ADDENDUM NO. 1

RE: Wake County East R Library Mechanical Replacement

DATE: August 15, 2025

M114

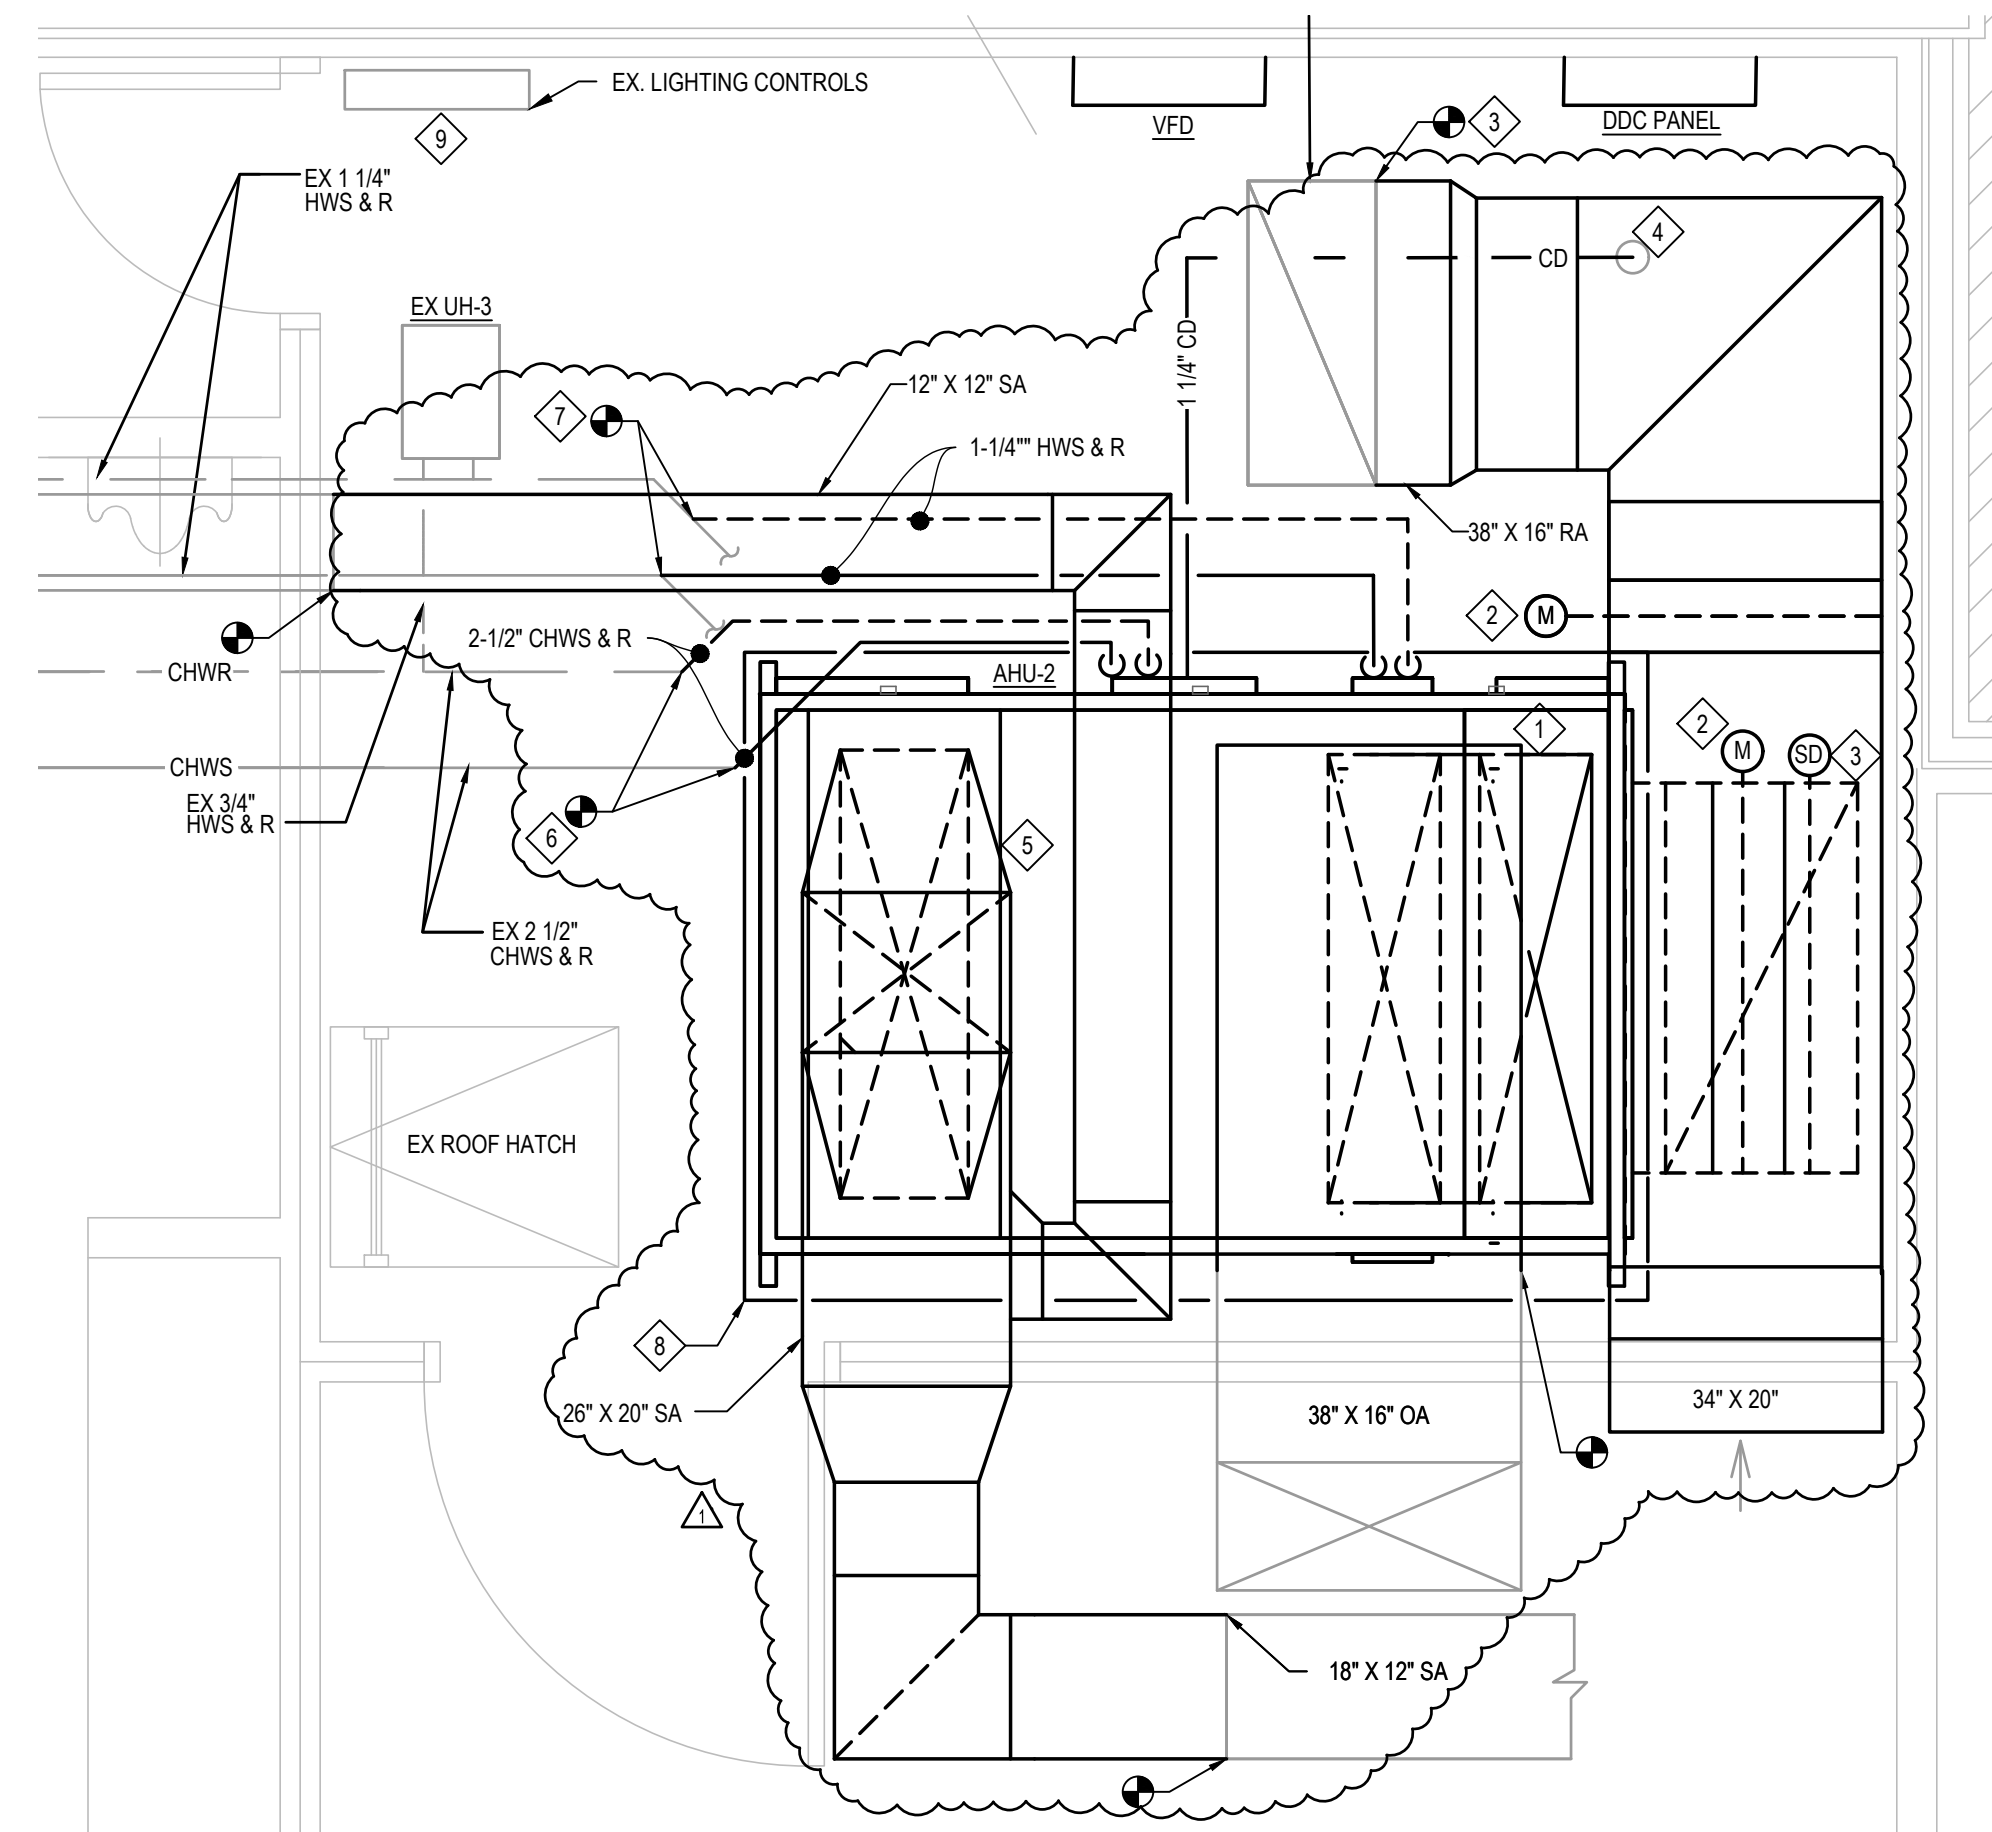
1. M114: Updated extent of demolition for existing return main duct.
2. M124: Updated location of AHU-2, duct connections, and hydronic piping connections to the unit.
3. M415: Updated AHU-2 component detail dimensions and fan location.
